TB1029

**LuK Part Nr: 228 0077 17 – 280/280mm TGU6**

**CNH**

**New design / Neues Design / Nouvelle conception / Nuevo diseño / Nuovo disegno**

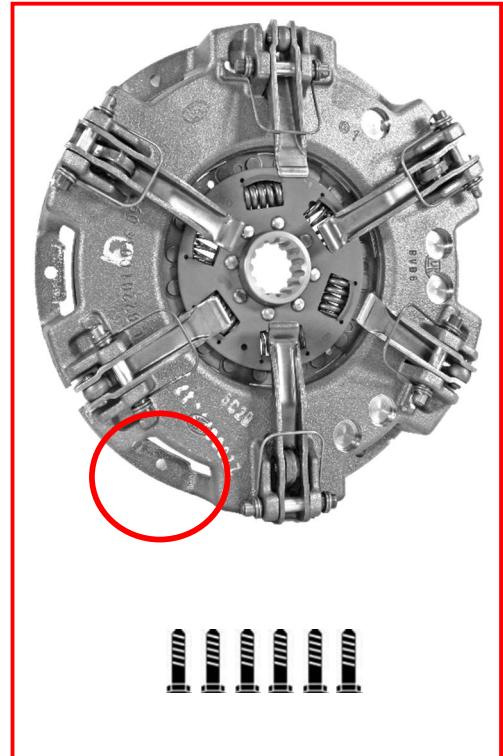
This new design utilises the latest clutch technology, using a vented housing for improved cooling and heat dispersal.

Fully interchangeable with existing clutches with no modifications required to vehicle or flywheel. A new fixation bolt set 6 x M8 x 1.25 x 50mm is supplied with new designs to accommodate the lower housing.
